CITY OF AUSTIN
Board of Adjustment/Sign Review Board
Decision Sheet

CASE NUMBER: C15-2014-0138

ADDRESS: 2921 WESTLAKE CV Bldg BD

CITY OF AUSTIN – PLANNING AND DEVELOPMENT REVIEW DEPARTMENT
SITE PLAN APPLICATION – MASTER COMMENT REPORT

2921 WESTLAKE COVE
SITE PLAN

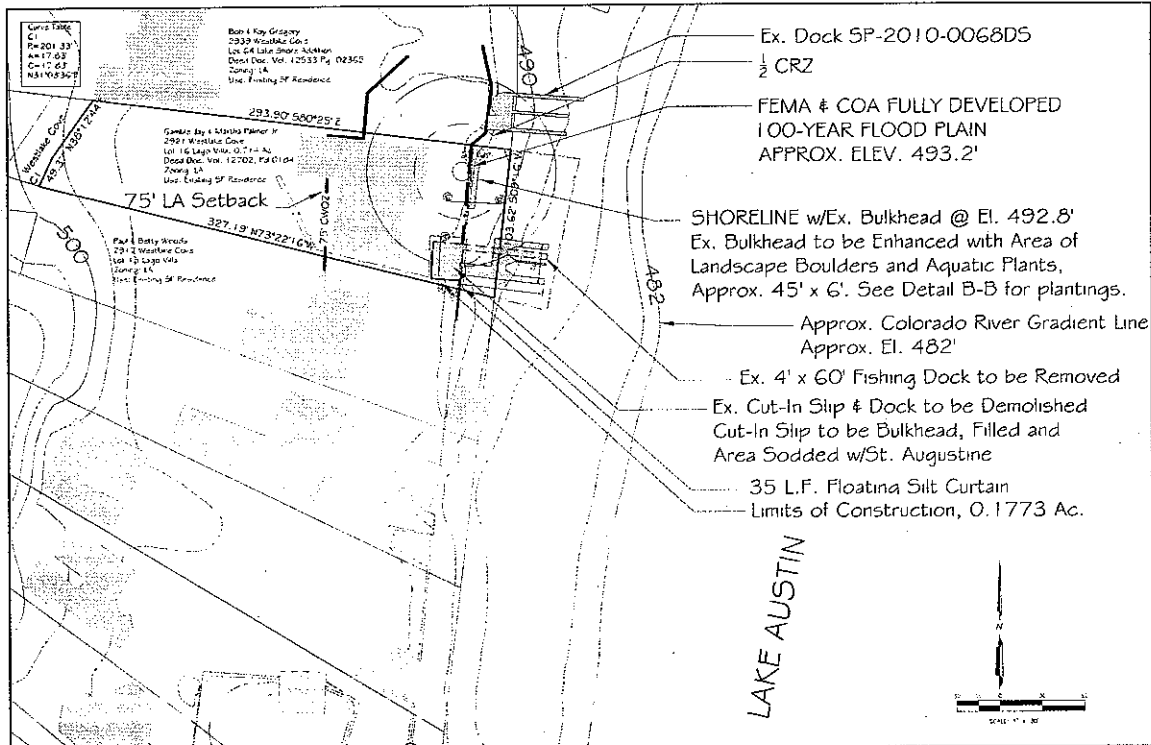
SP 12. It appears that the proposed boat dock extends approximately 60 feet from the shoreline, exceeding the allowed maximum of 30 feet [Section 25-2-1176(B)(2)]. Either reduce this extension into the lake, or request approval from the Planning Commission.

U1: Comment to remain until PC approval. Please clarify why the proposed dock is this long.

SP 13. The proposed width of the boat dock exceeds twenty percent (20%) of the length of the shoreline and must get approval from the Planning Commission.

U1: Comment to remain until PC approval. Please clarify why the proposed dock is exceeding the 20% shoreline width.

WB3.update0. This reviewer does not find compelling reason to support the proposed width of dock structure in excess of 20% of the shoreline. Please revise dock structure to within 20%.

WB4.update0. This reviewer does not find compelling reason to support the proposed extent of dock beyond 30ft from shoreline. Please revise dock structure to within 30ft from shore.

2921 WESTLAKE COVE
DOCK ELEVATIONS & PLAN VIEW

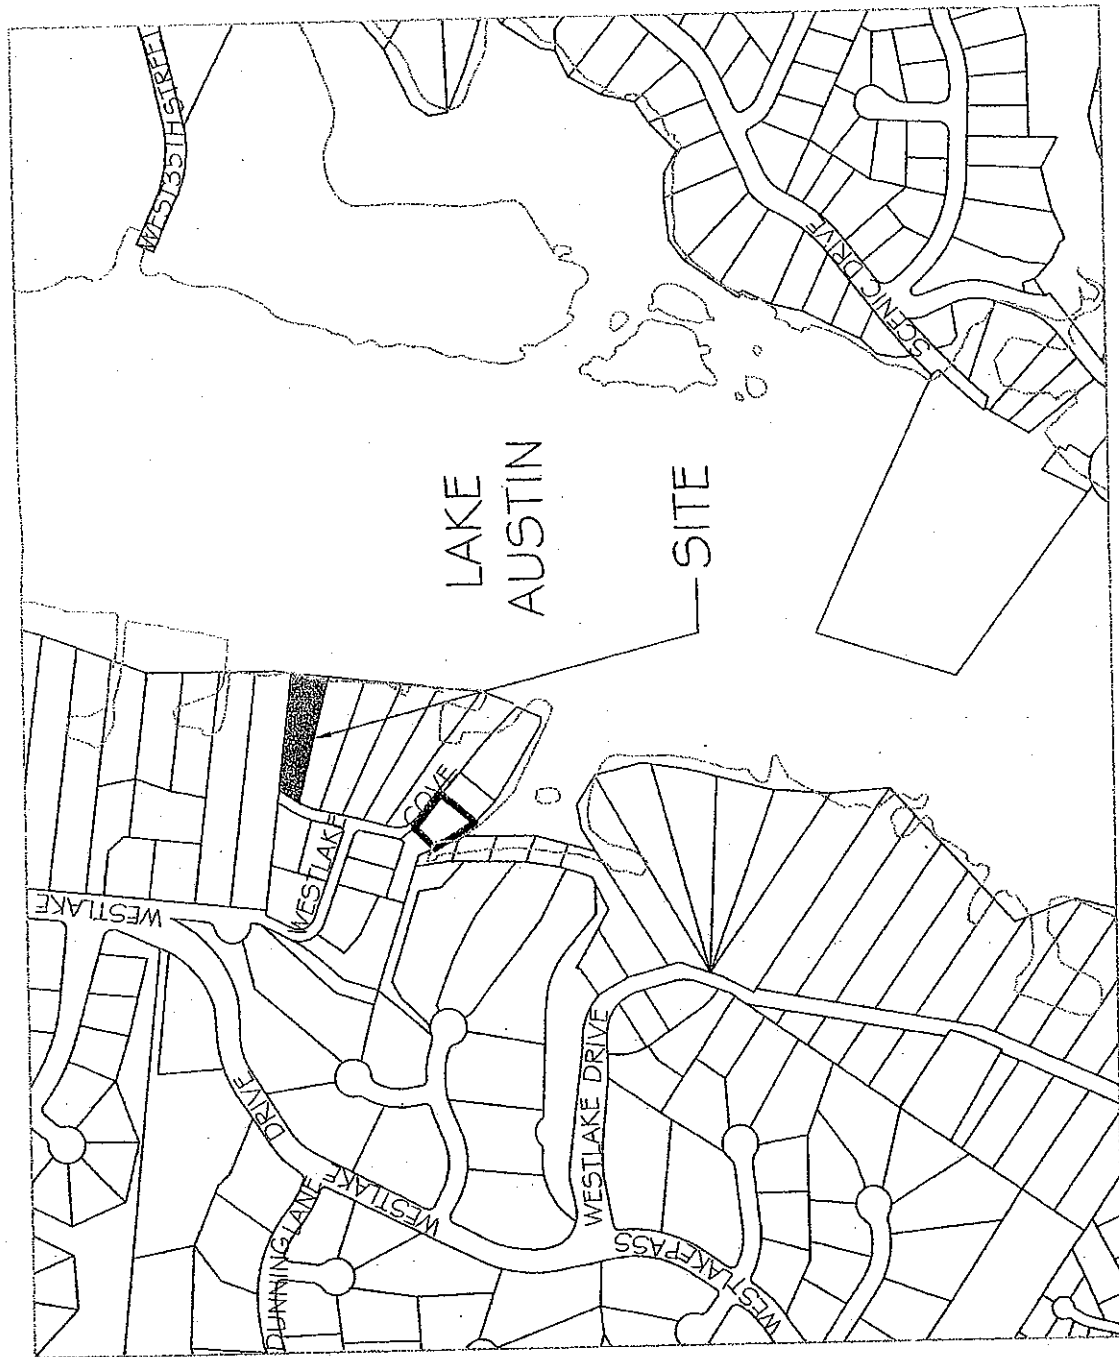
SP 17. **Please add dock dimensions (height) on page 3.**
